CITY OF ST. HELENS PLANNING DEPARTMENT

MEMORANDUM

TO: Planning Commission
FROM: Jacob A. Graichen, AICP, City Planner
RE: City Council remand of Appeal AP.2.24 – AP.6.24 (CUP.2.24 & V.8.24 V.11.24) back to the Planning Commission
DATE: February 28, 2025

**CITY OF ST. HELENS PLANNING DEPARTMENT
FINDINGS OF FACT AND CONCLUSIONS OF LAW
Conditional Use Permit CUP.2.24 & Variances V.8.24 - V.11.24 (four Variances total)**

SITE PLAN

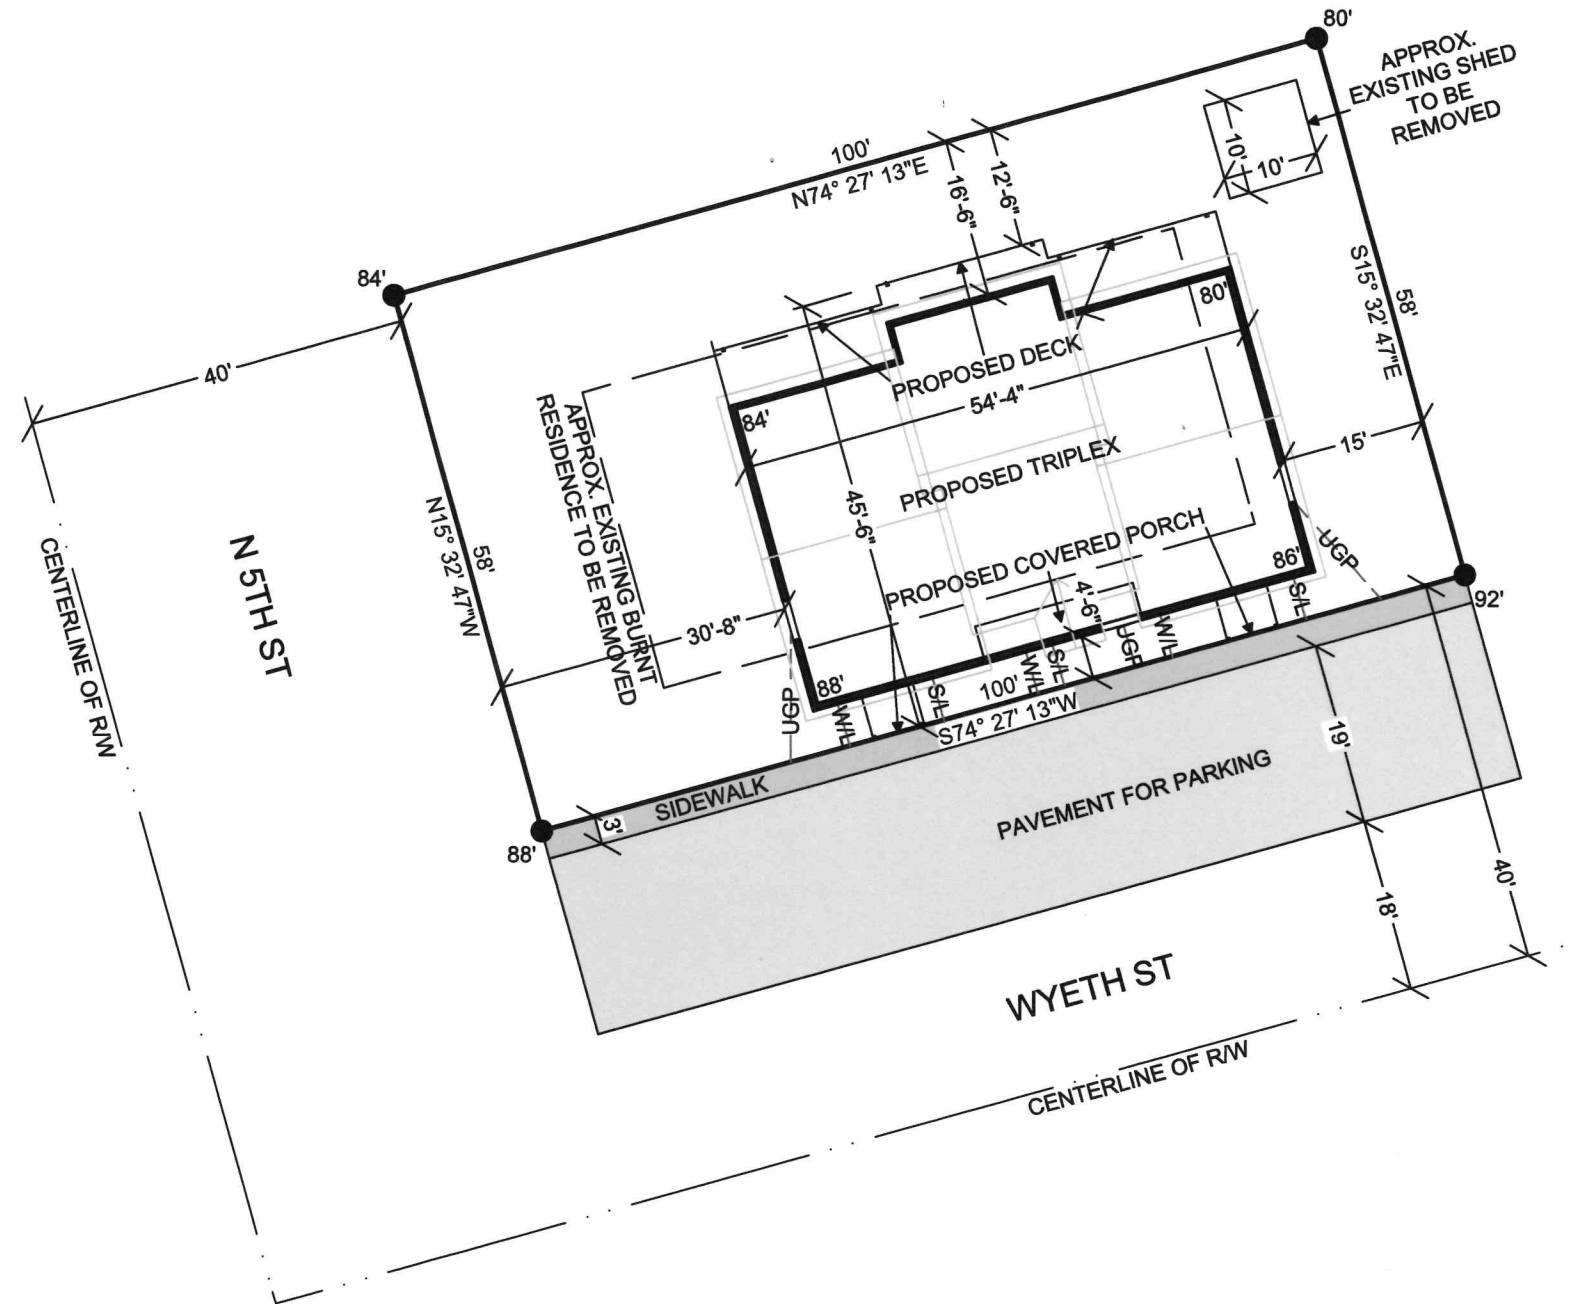
Min front yard (from N 5th Street) is 20 feet. Site plan shows approximately 30’.

Min rear yard (opposite N 5th Street) is 10 feet. Site plan shows 15 feet.

Min exterior yard (corner lot) along Wyeth is 10 feet. Site plan shows 4.5 feet. **Need Variance:** see V.9.24. This was denied by the Commission.

Min side yard (opposite Wyeth) is 10’ for multifamily structures. Site plan shows 12.5 feet.

Maximum building/structure coverage is 50% for multifamily development. ½ of the lot size is 2,900 square feet. The sole building proposed has a footprint of approximately 2,200 square feet.

Non-living windowed room areas are along the Wyeth Street side of the building. Provided the existing sidewalk does not move (which is shown incorrectly on the preliminary plans as the sidewalk does not abut the property line), there should be 8' of separation, but maybe not 10 feet. Living room areas are proposed on the opposite side of the building from Wyeth Street.

FRONT ELEVATION

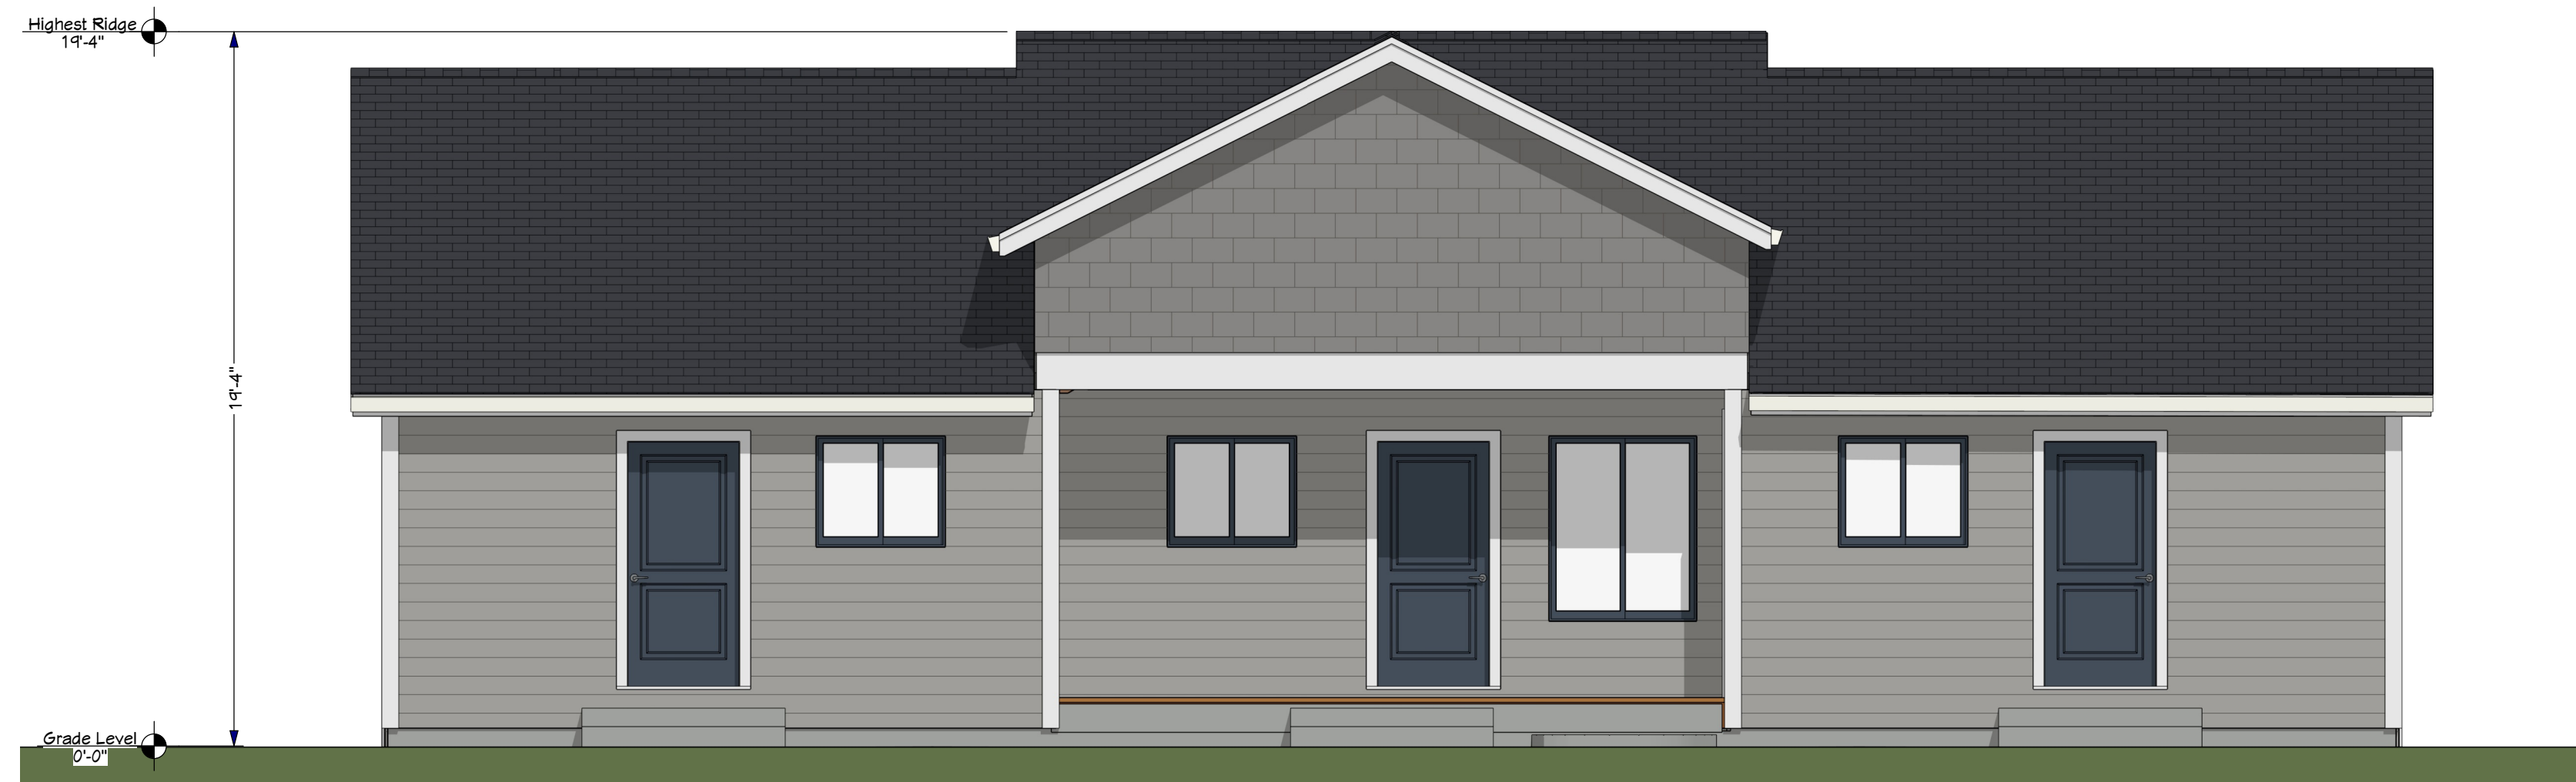
This is not met; **Need Variance:** see V.10.24. The Commission denied this Variance.

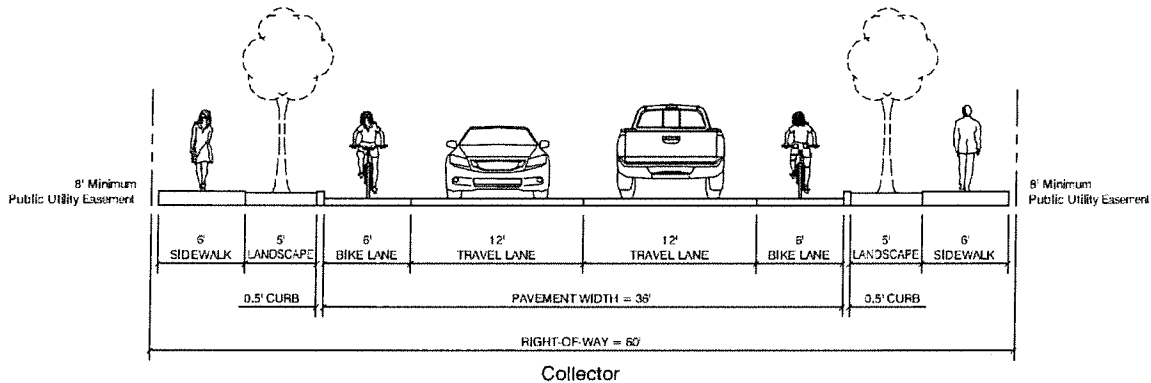
Along the vertical face of single-dwelling units – attached and multiple-dwelling unit structures, offsets shall occur at a minimum of every 30 feet by providing any two of the following:

- (a) Recesses (decks, patios, entrances, floor area, etc.) of a minimum depth of eight feet;
- (b) Extensions (decks, patios, entrances, floor area, etc.) of a minimum depth of eight feet, and maximum length of an overhang shall be 25 feet; and
- (c) Offsets or breaks in roof elevations of three or more feet in height;
